Tennessee Valley Authority, Post Office Box 2000, Spring City, Tennessee 37381

WATTS BAR NUCLEAR PLANT (WBN) - CHANGES TO FINAL SAFETY ANALYSIS REPORT (FSAR) CHAPTER 8 TO RESOLVE AMENDMENT 90 ISSUES

PROPOSED CHANGES TO
FINAL SAFETY ANALYSIS REPORT (FSAR)
SECTIONS 8.2.1.8, 8.2.2, AND 8.3.1.4.3

HYDRO & STEAM POWER STATIONS
WIRING DIAGRAMS
DEVELOPMENT SINGLE LINE
TVA DWG NO. 45N501 R27
FIGURE 8.2-1A

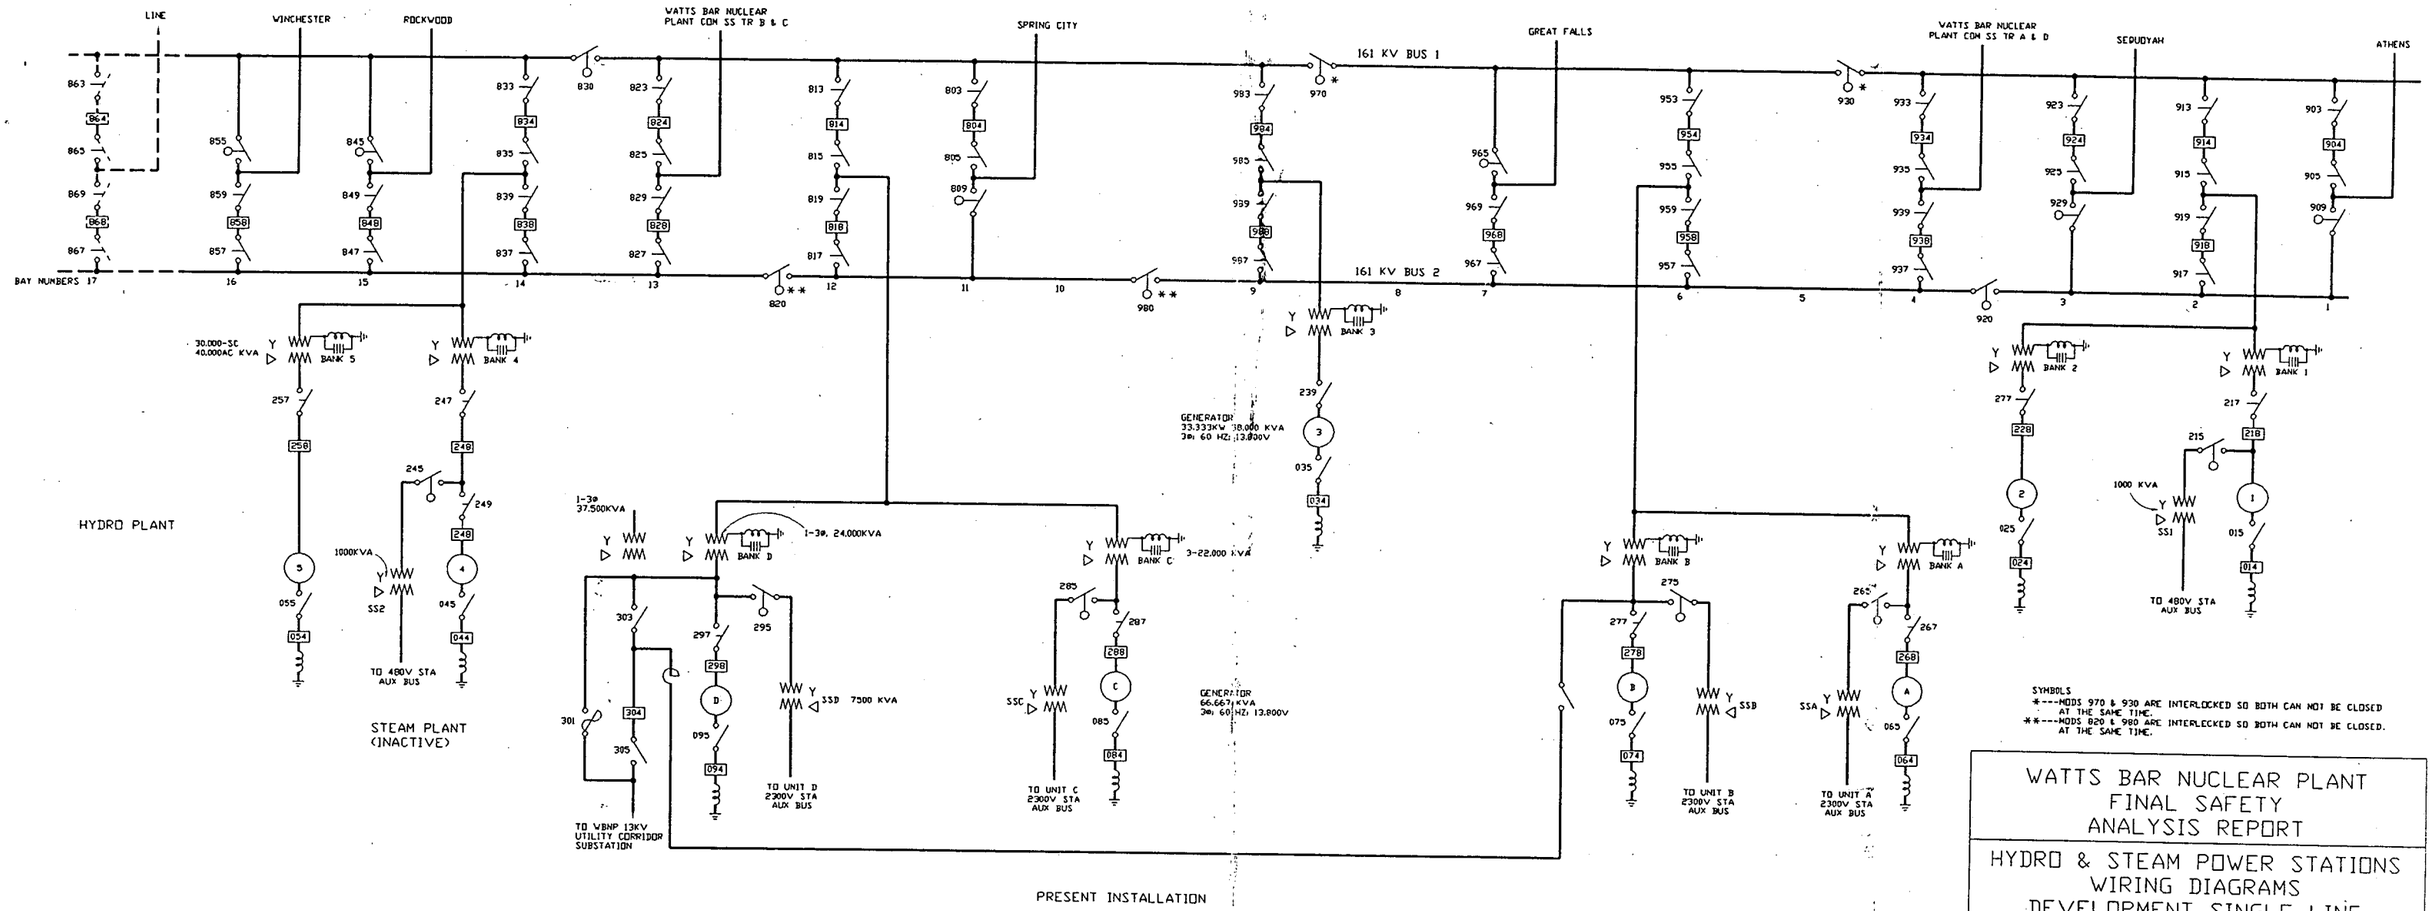
In addition, enclosed is a draft of Figure 8.2-1A which corrects minor drawing errors that involved duplicate equipment numbers for breakers and disconnect switches.
